# Information of Discontinued Models

## Adjustable long range & fixed-focus reflective photoelectric sensor MR3 series

Stopping taking order date: 30, Sep, 2005  
Date of production discontinuance: 31, Dec, 2005

Adjustable range reflective photoelectric sensor  
EQ-500 series

### Dimensions (Unit: mm in)

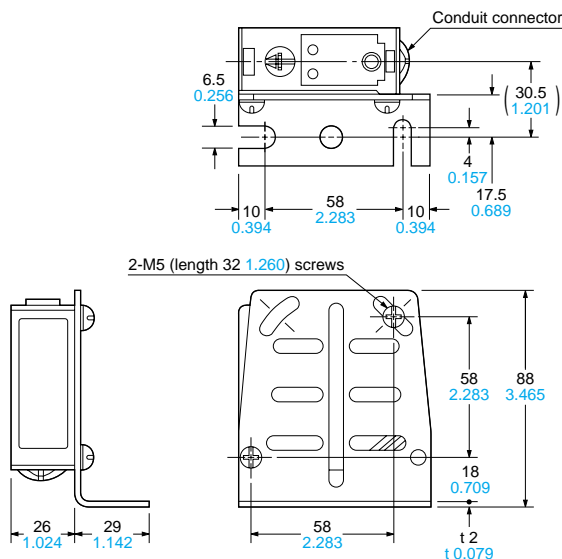
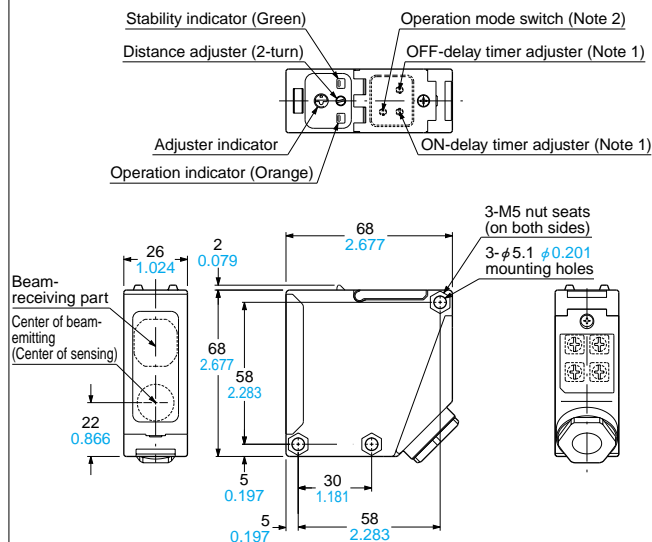
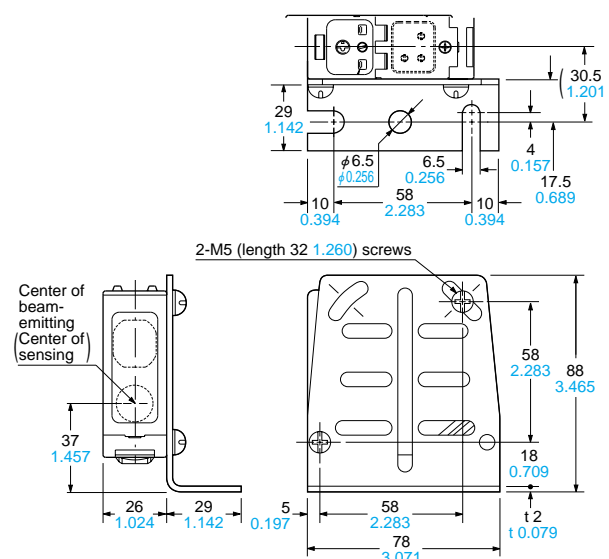
- High degree of interchangeability in specifications, mounting dimensions and operability, so that replacement of the **MR3** series with the **EQ-500** series can be carried out smoothly.
- The sensors with a timer function in the **MR3** series are provided with ON-delay / OFF-delay / ONE SHOT timers, but the sensors with a timer function in the **EQ-500** series are only equipped with an ON-delay / OFF-delay timer.
- The sensor mounting bracket is not attached with **EQ-500** series.
- The recommended replacements have blind sectors.

Model No.	Sensing range	→	Model No.	Sensing range	
MR3-M100P-12-240VCE	0 to 1 m 0 to 3.281 ft	→	EQ-502	0.1 to 1.0 m 0.328 to 3.281 ft	● The recommended replacements have 0.1 m 0.328 ft blind sectors. Note: The recommended replacements have a sensing range of 2.5 m 8.202 ft.
MR3-M100PT-12-240VCE	0 to 1 m 0 to 3.281 ft	→	EQ-502T	0.1 to 1.0 m 0.328 to 3.281 ft	
MR3-M200P-12-240VCE	0 to 2 m 0 to 6.562 ft	→	EQ-501 (Note)	0.1 to 2.5 m 0.328 to 8.202 ft	
MR3-M200PT-12-240VCE	0 to 2 m 0 to 6.562 ft	→	EQ-501T (Note)	0.1 to 2.5 m 0.328 to 8.202 ft

Notes: 1) EQ-5□T incorporate those.

2) The operation mode switch of the DC-voltage type is the DIP switch.
